Title of Change:	Revision of Case Outline 507BA
Effective date:	05 Jul 2024
Contact information:	Contact your local onsemi Sales Office or saziela.senin@onsemi.com
Type of notification:	This Product Bulletin is for notification purposes only. onsemi will proceed with implementation of this change upon publication of this Product Bulletin.
Change Category:	Assembly Change
Change Sub-Category(s):	Datasheet/Product Doc change
Sites Affected:	
onsemi Sites	External Foundry/Subcon Sites
onsemi Seremban, Malaysia	None

MECHANICAL CASE OUTLINE PACKAGE DIMENSIONS

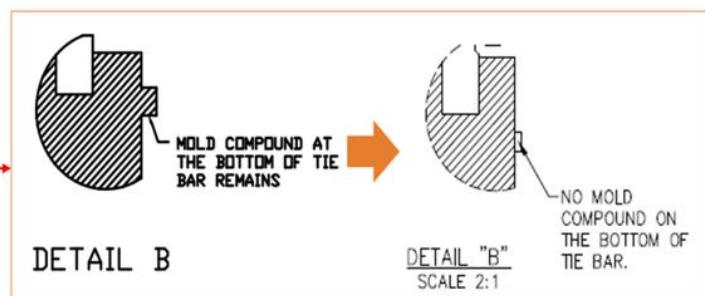
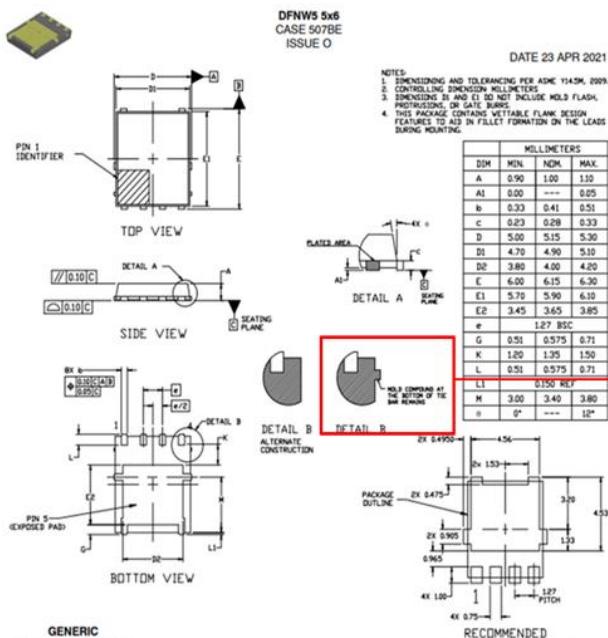
This Product Bulletin is to advise customers of a change to detail B in case outline from "Mold compound at the bottom of tie bar remains" to "No mold compound at the bottom of the tie bar" for case 507BE. No change to solder footprint is required. There is no material, dimension or manufacturing change.
